UNUSUAL RATTLE / BUZZ TYPE NOISE FROM PRESILENCER

Bulletin No: 01-026/12

2010-2013 CX-9 vehicles with VINs from JM3 TB ***** 200001 to JM3 TB ***** 400869 (produced from July 28, 2009 to October 15, 2012)

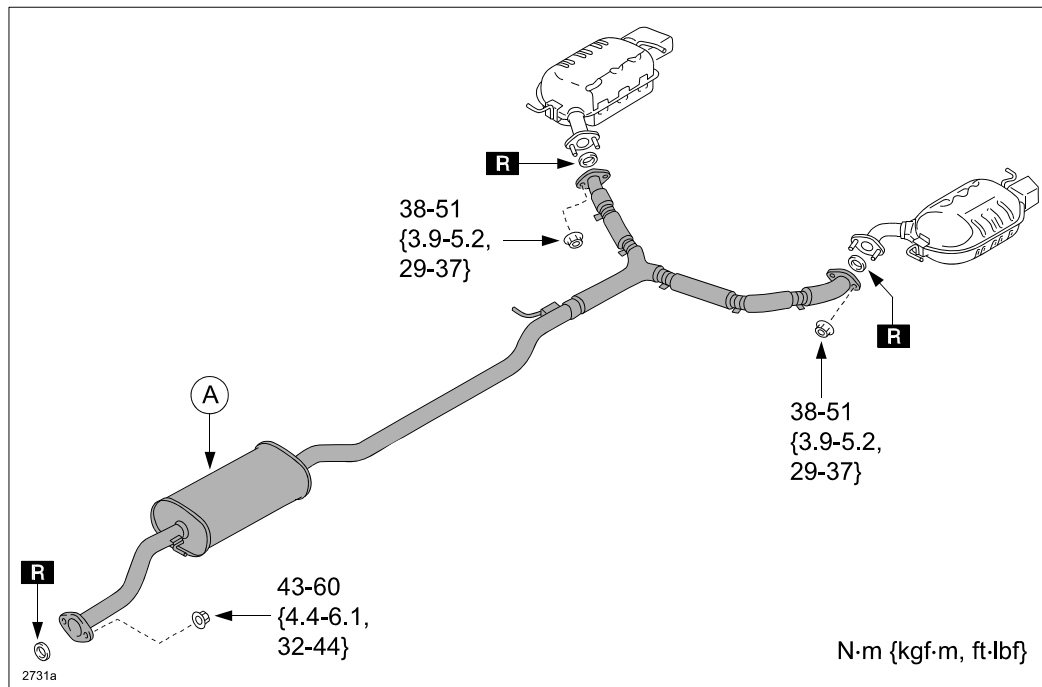
Some vehicles may exhibit an unusual rattle/buzzing type noise from the presilencer when driving at approximately 1800 rpm.

1. Verify customer concern.
2. Replace the presilencer (A). Refer to MS3 online or Workshop Manual (section 01-15 EXHAUST SYSTEM REMOVAL/INSTALLATION [MZI-3.7]).
